**SYDNEY NORTH PLANNING PANEL**  
**COUNCIL ASSESSMENT REPORT**

<b>Panel Reference</b>	2019SNH018 DA
<b>DA Number</b>	DA115/11/04
<b>LGA</b>	North Sydney Council
<b>Proposed Development</b>	<b>Modification to DA 115/11 pursuant to S.4.55(2) including modifications proposing internal changes to basement layout and uses; changes to car parking allocation and storage; landscape changes; fence and pedestrian entry change; changes to stormwater arrangements; front balustrade change and installation of an external access ladder to rear of building for building maintenance.</b>
<b>Street Address</b>	106 Kirribilli Avenue, Kirribilli
<b>Applicant/Owner</b>	A Plus Group Pty Ltd C/- Redgen Matheson Pty Ltd
<b>Date of DA lodgement</b>	28-Sep-2018
<b>Number of Submissions</b>	Four (4)
<b>Recommendation</b>	Approval
<b>Regional Development Criteria (Schedule 7 of the SEPP (State and Regional Development) 2011</b>	<b>General Development (Ref Cl 23G of EP &amp; A Act &amp; Cl 21 SEPP State and Regional Development) 2011)</b> <b>Original Consent determined by Sydney East JRPP</b> <b>Capital Investment Value Exceeds \$10M as applicable to the originally approved development application.</b>

**S.4

**Figure 10.** Proposed amended north elevation

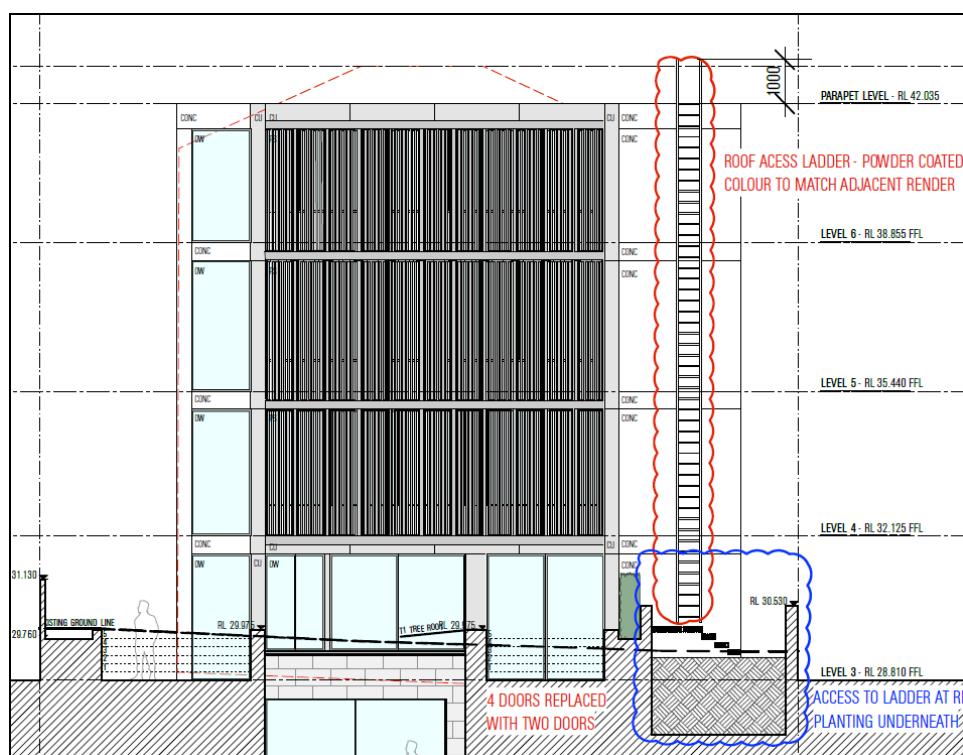
The proposed ladder however, does not comply with the height standard and would protrude 1.0m above the roof level to enable maintenance access to the roof. Whilst the visual impact of the structure is considered to be unacceptable from aesthetic considerations, the structure is a minor addition to the building and the variation to the height control would not adversely affect existing views.

**2. That Condition A20 be imposed to delete the proposed roof access ladder showing he the northern elevation of the building. Condition A20 is imposed as follows:**

**Delete proposed roof access ladder**

**Figure 11.** View corridor across the site from No. 65 Upper Pitt Street

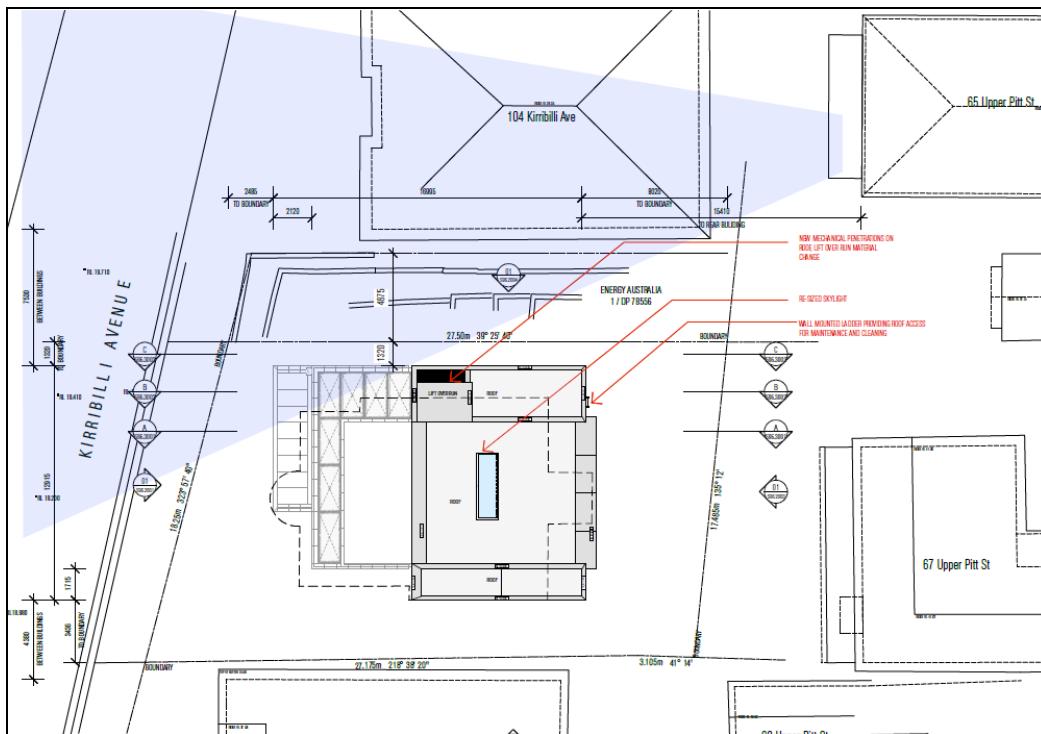
The building envelope of the modified development would not present any additional view impacts to surrounding properties. The proposed installation of an access ladder to the north western corner of the building would not result in any significant adverse effect in relation to view loss as the existing large port Jackson fig is to be retained and currently obscures city and harbor views across the site from the north-west and properties at 65 Upper Pitt Street ads indicated in the images below.

**Figure 13** View Corridor –65 Upper Pitt Street

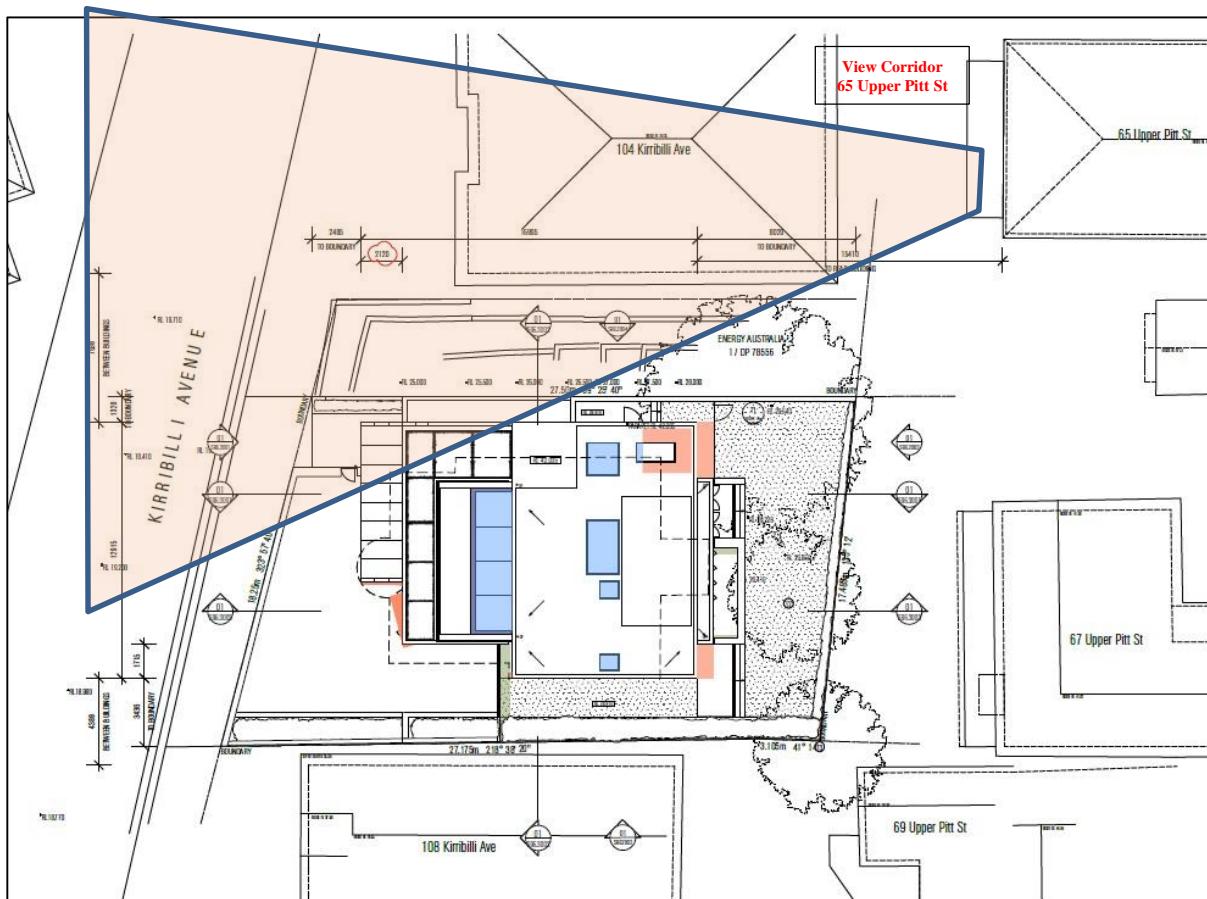
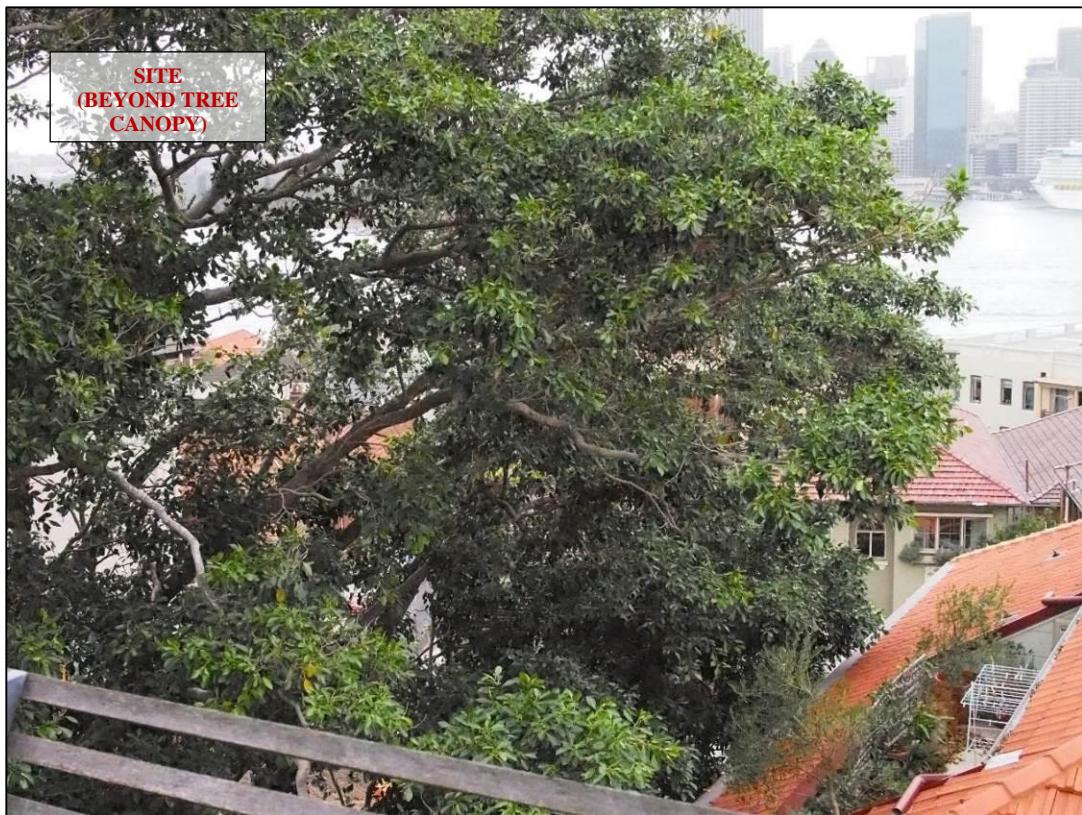
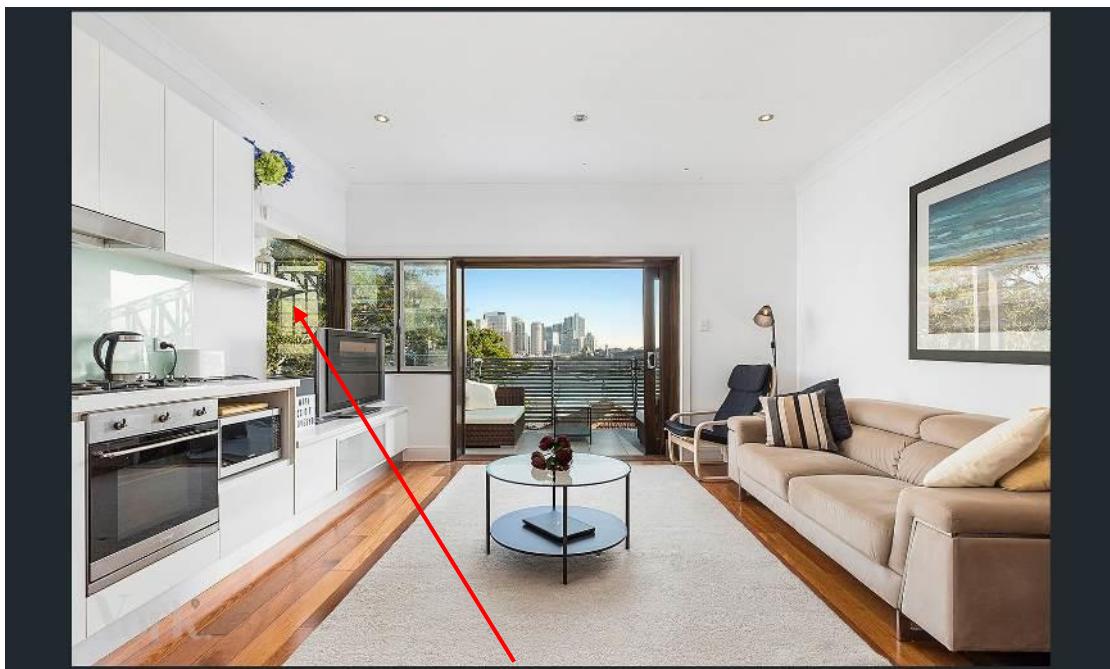
The concerns raised by the adjoining owners of **4, 8 & 9/65 Upper Pitt St** have been considered in the assessment. The impact to existing view arising from the proposed modifications is assessed as low to negligible, with the modified development generally consistent with the approved development.
